Executive Director's Recommendation

Commission Meeting: July 13, 2017

PROJECT President Franklin D. Roosevelt Prayer Plaque World War II Memorial The National Mall Washington, DC	NCPC FILE NUMBER 7727
SUBMITTED BY United States Department of the Interior National Park Service	NCPC MAP FILE NUMBER 00.00(73.10)44572
REVIEW AUTHORITY Federal Projects in the District per 40 U.S.C. § 8905 and Public Law 113-123	APPLICANT'S REQUEST Approval of comments on concept design
	PROPOSED ACTION Approve comments on concept design
	ACTION ITEM TYPE Staff Presentation

D-Day Prayer Scheme A

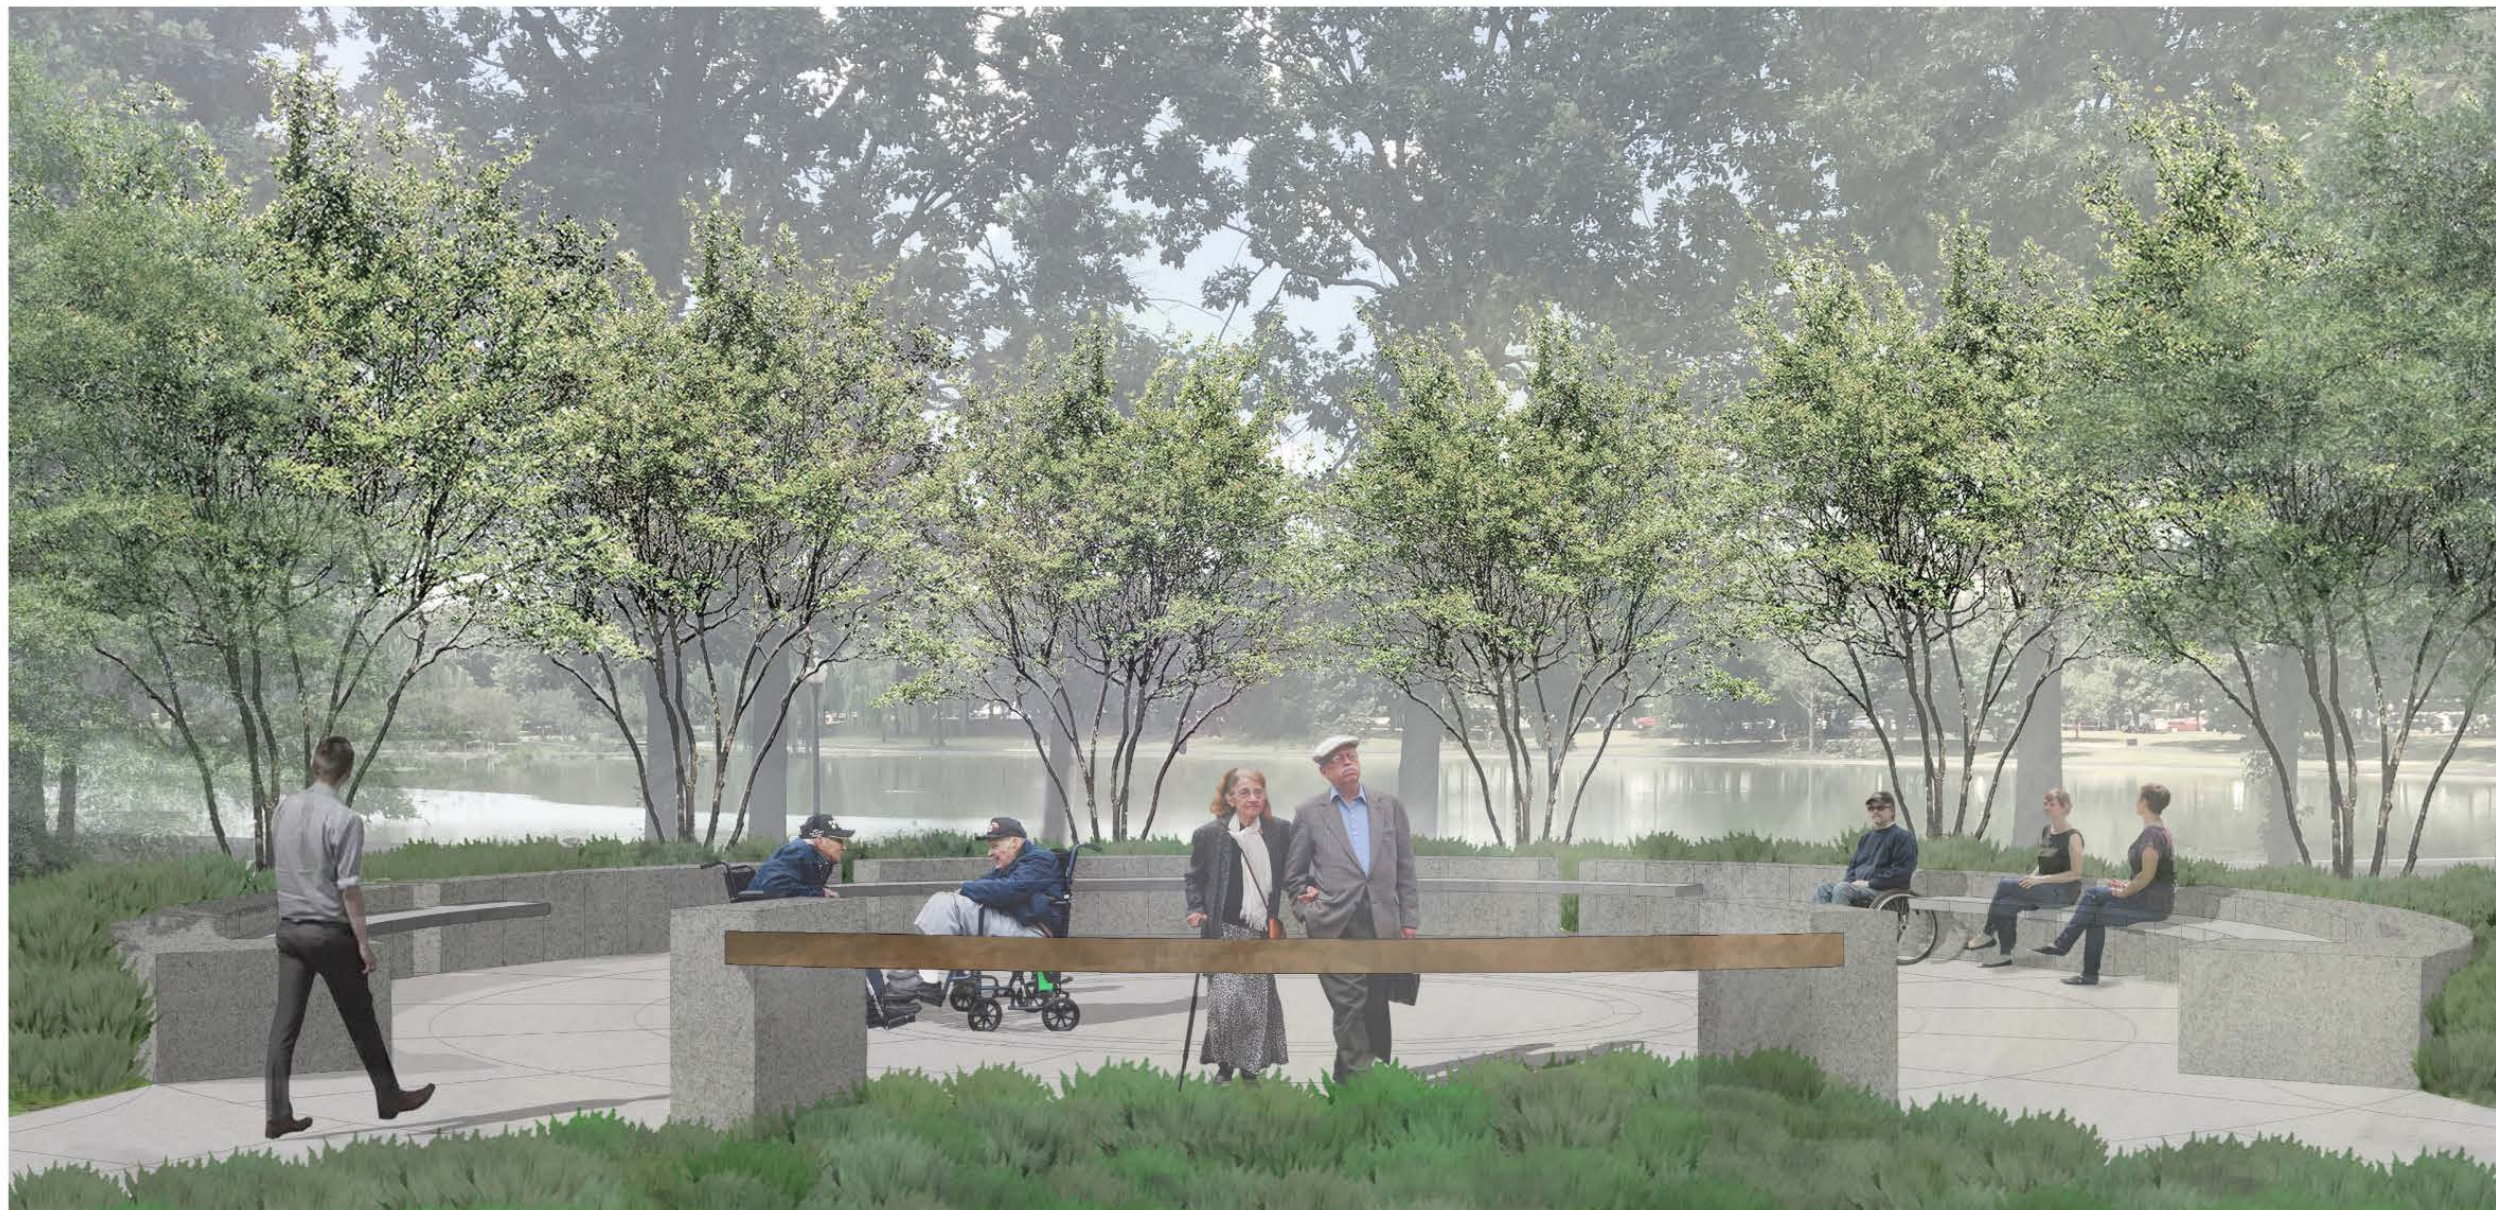
- FDR Prayer Plaque is prominently located and clearly distinguished from the Circle of Remembrance in a free-standing manner between two pedestrian paths.
- Circulation is flexible; two entry/exit points provide more circulation space and pedestrian routes.
- Provides more standing area and seating spaces (including two more wheelchair spaces) than Alternative B.
- Gaps allow for views into the landscape, and diminish the monolithic sense of the retaining wall.
- Preserves views to surrounding sites.

- Existing pathways may be too wide or too close to the plaque viewing and contemplation area. The circulation spaces may compete with the size and area of the contemplation space within the Circle of Remembrance.
- Unnecessarily symmetrical form.

In addition to the pros and cons listed previously, staff notes that Alternative A is similar to the plaque location and design supported by the Commission in December 2016 because it completes the geometric form of the circle.

D-Day Prayer Scheme B

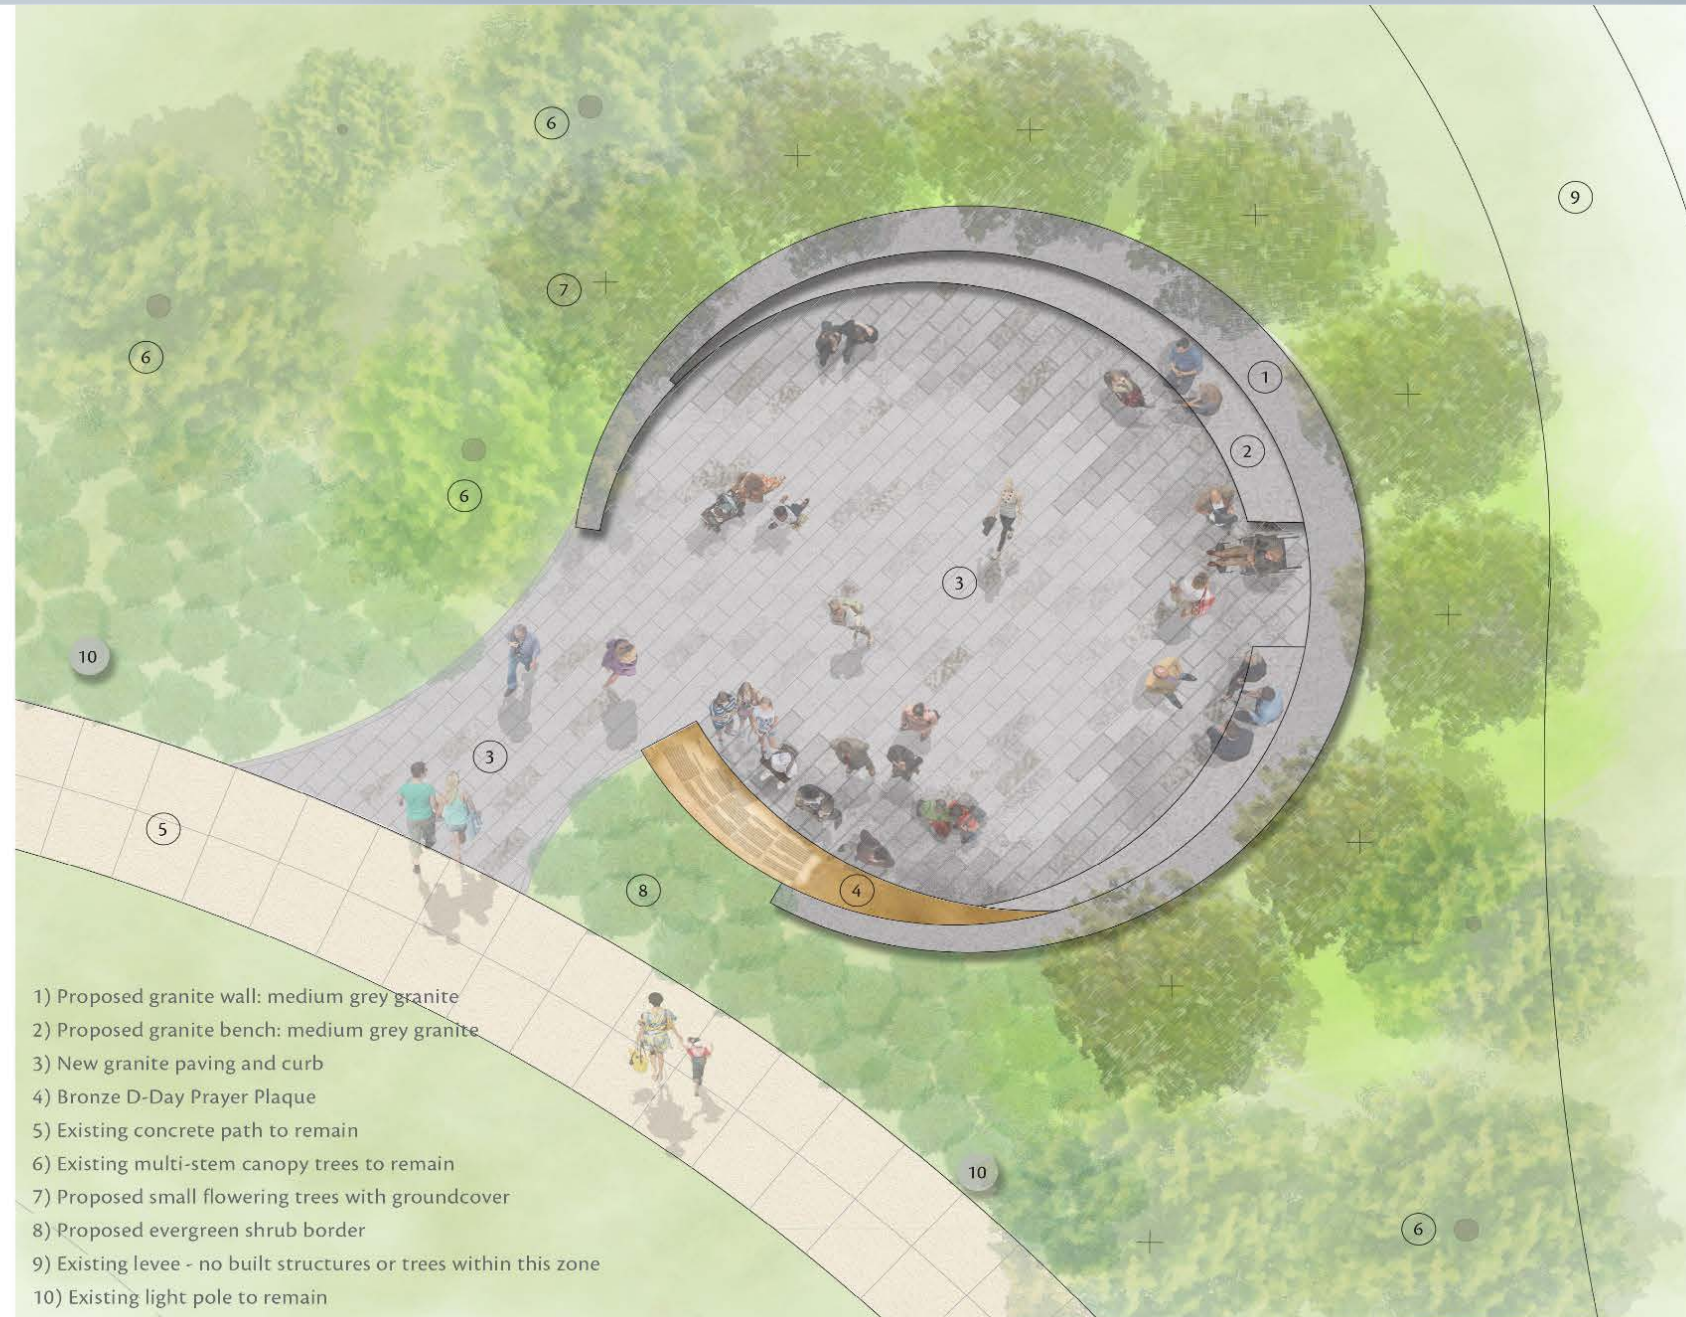
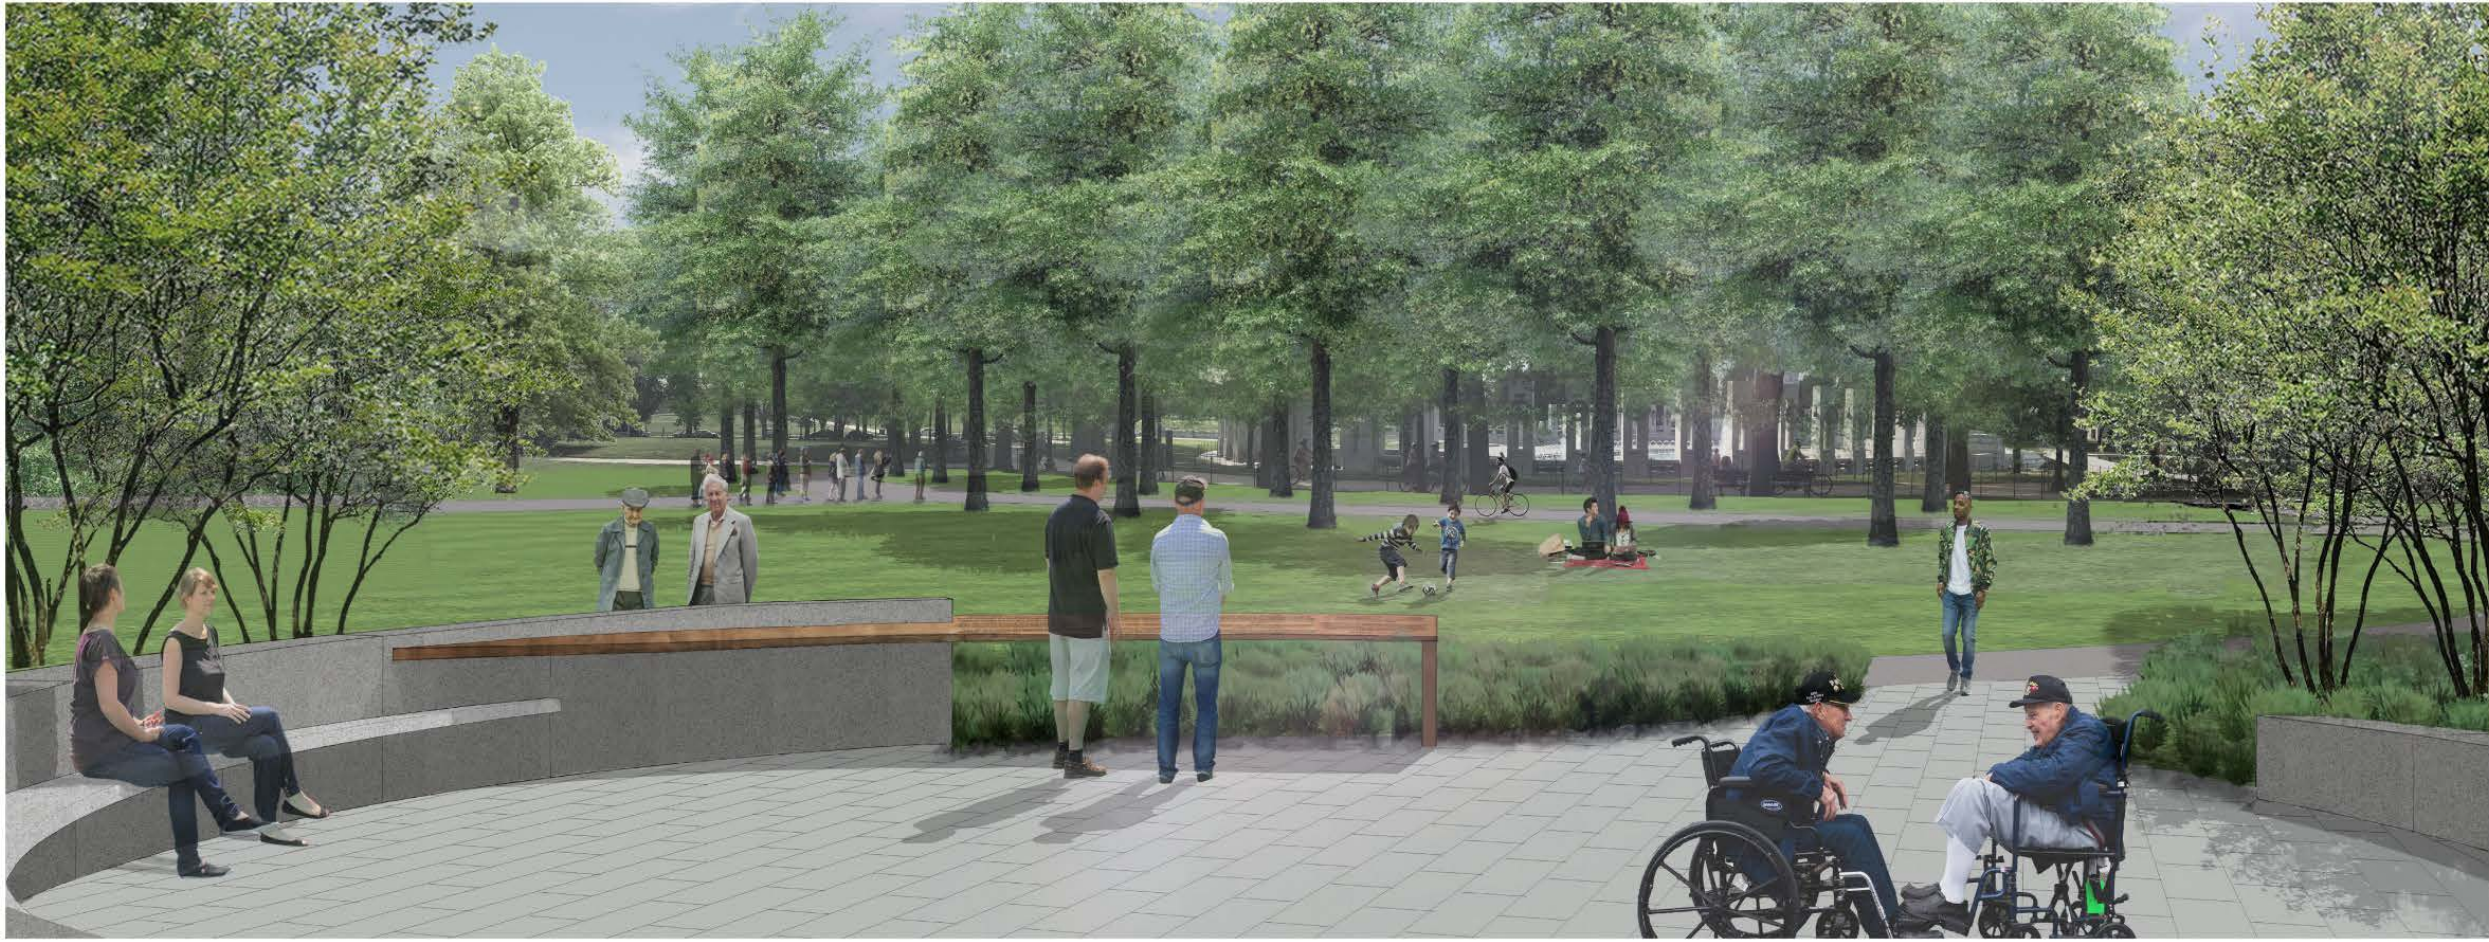
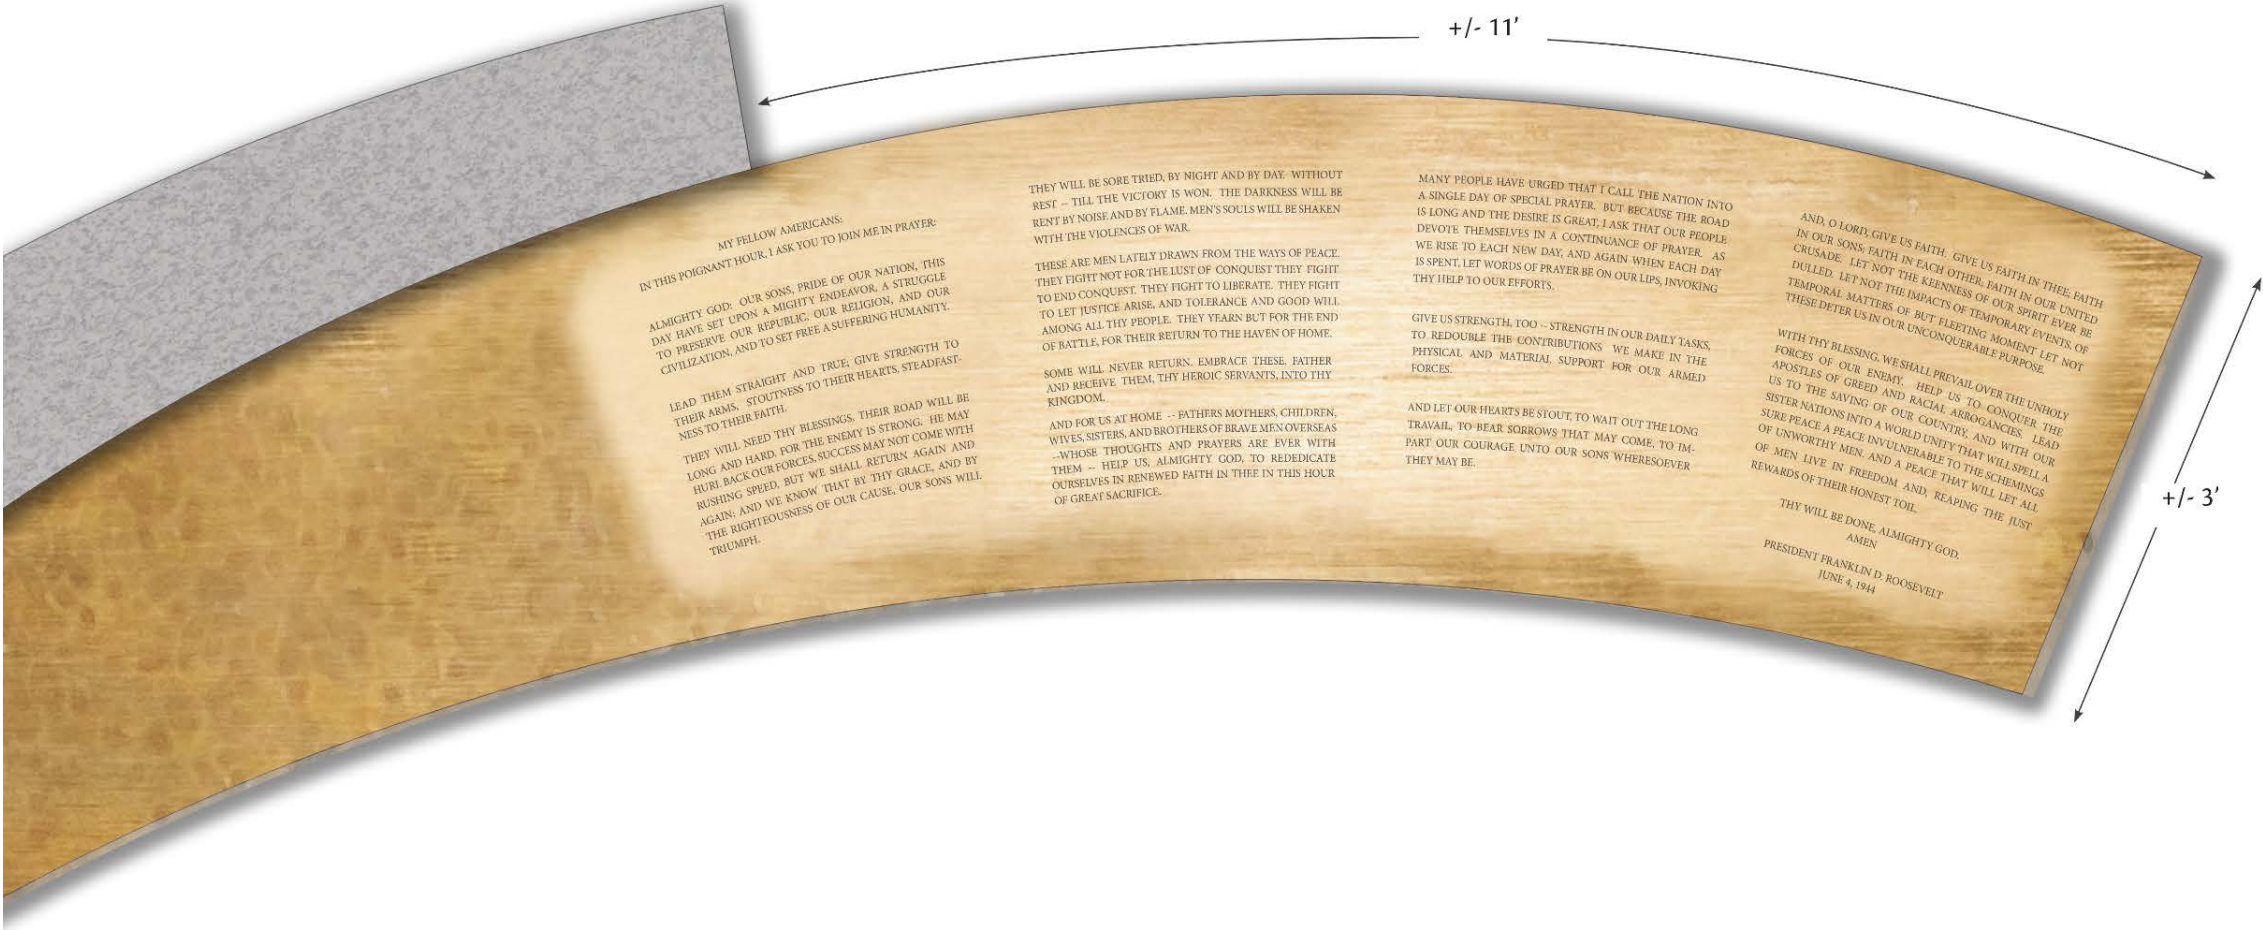
- Modifies existing circulation and visitation patterns; a deviation from the applicant's previous evaluation criterion.
- Design style and character differs from the primary memorial precinct; a deviation from the applicant's previous evaluation criterion.
- Repositions the Circle of Remembrance, which results in greater impacts to the existing landscape and vegetation.

- Circulation is limited; one entry/exit point provides less circulation space and pedestrian routes.
- Provides less standing area and seating space (including two fewer wheelchairs spaces) than Alternative A.
- FDR Prayer Plaque is weakly distinguished from other elements within the Circle of Remembrance; the benches and retaining wall, which should have a lower hierarchy than the plaque.
- Text may be difficult to read on the curving plaque.
- The retaining wall and benches are monolithic and do not allow views into the landscape.

Universal accessibility issues were raised during the consultation process. Blind pedestrians may not be able to detect the 36-inch tall plaque at ground level. The plaque could become an obstacle, and the sharp corners of the bronze plaque could be dangerous. A program for the FDR Prayer Plaque has not been defined. The applicant should consider what types of ceremonies, services, or events might occur and how much visitation the plaque or inscription will receive once it is in place.

In summary, staff notes that Alternative B repositions the Circle of Remembrance, modifies existing circulation patterns, and expresses a difference character from the primary WWII Memorial precinct. However, staff finds that Alternative B has a distinct contemporary design, locates the plaque prominently within the Circle of Remembrance, and preserves views to surrounding sites. Therefore, staff requests that the Commission support Alternative B.

At a future date, NPS will submit the plaque for preliminary and final approval. Staff recommends that the applicant continue refining the design and consider the following issues:

- Improve universally accessible (ABAAS-compliant) circulation into the Circle of Remembrance and around the plaque, while deterring pedestrian cut-throughs.
- Ensure ample accessible seating spaces for the anticipated visitor population.
- Create comfortable standing and sitting spaces for reading the plaque and contemplating, away from the entry/exit space.
- Improve the plaque design to promote text legibility, establish a clear hierarchy of the plaque above bench and wall elements, and discourage unintended uses such as sitting or sleeping.
- Provide porosity within the solid retaining wall to allow views into the surrounding landscape.
- Incorporate low-maintenance vegetation that promotes long-term legibility of the plaque.
- Coordinate the repositioned location of the Circle of Remembrance and landscape planting plans with the Potomac Park Levee Project.
